**Re: Comments on Final Environmental Impact Statement for Hay Creek II Coal Project**

## BLM Response

#### Ten Highest Daily PM10 Max Values at the Campbell County Monitor

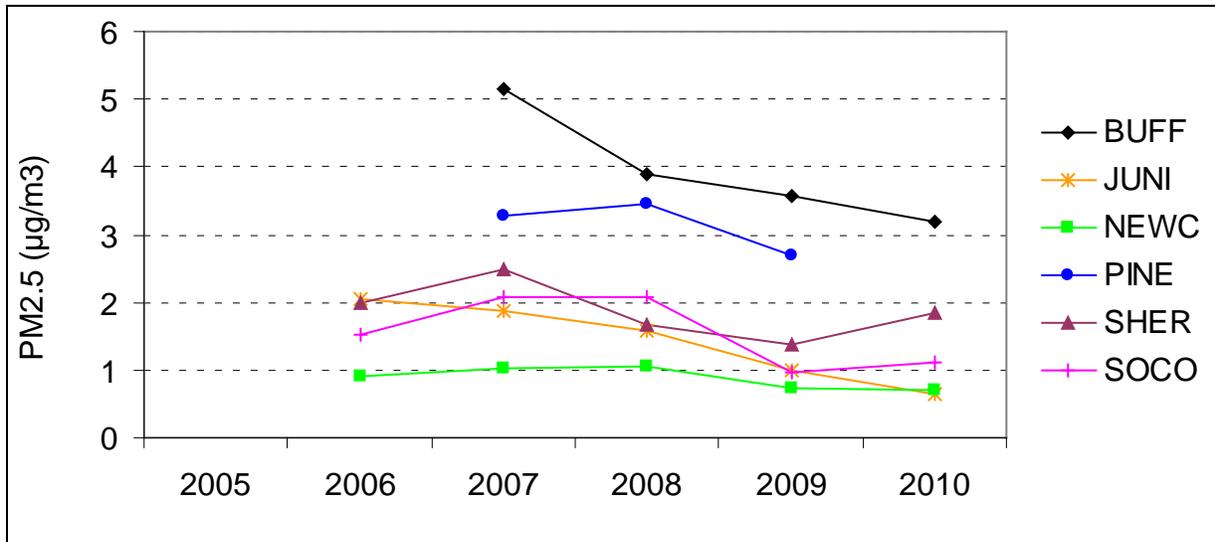
We are particularly concerned with regards to indirect and cumulative impacts. For one thing, the BLM’s own analyses have found that cumulatively, approval of the Hay Creek II Coal Lease will lead to violations of the annual PM<sub>2.5</sub> NAAQS, the 24-hour PM<sub>2.5</sub> NAAQS, and the 24-hour PM<sub>10</sub> NAAQS. *See* FEIS at 4-44. The FEIS also shows violations of the one-hour NO<sub>2</sub> NAAQS (although only in Montana—BLM has not assessed such impacts in Wyoming). *Id.* Although the BLM may simply claim that the State of Wyoming will ensure protection of the NAAQS, this is a self-serving argument of convenience. There is nothing in the FEIS that indicates the State of Wyoming has any mechanism in place to ensure that the NAAQS are not violated. This is particularly true for the 24-hour PM<sub>10</sub> NAAQS. Although the State of Wyoming relies on monitoring data in lieu of modeling, the State has yet to adopt and enforce any limits on PM<sub>10</sub> emissions from the Buckskin Mine, despite registered exceedances. *See* FEIS at 3-52.<sup>1</sup> Put simply, the State of Wyoming makes every effort to avoid taking any action to address air quality problems in the Powder River Basin. The BLM cannot reasonably rely on such an approach to protecting air quality, particularly when the Agency has an explicit and independent mandate to provide for compliance with air quality standards.

Data from a WDEQ monitor in Campbell County are shown in the following table, which displays the ten highest daily maximum values from July 2003 to June 2012. Note that all maximum values are well below the 24-hr PM10 NAAQS of 150  $\mu\text{g}/\text{m}^3$ . According to recent communication with the WDEQ, the WDEQ considers a representative 24-hr PM10 background concentration for the High Plains District of the BLM to be approximately 41  $\mu\text{g}/\text{m}^3$ .

number	date	value ( $\mu\text{g}/\text{m}^3$ )
1	6/27/2012	59.3
2	6/28/2012	53.3
3	4/11/2012	50.4
4	6/4/2012	50.3
5	6/30/2012	47.6
6	8/24/2011	47.5
7	4/10/2012	47.2
8	5/15/2012	45.5
9	6/26/2012	44.8
10	9/17/2009	44.5
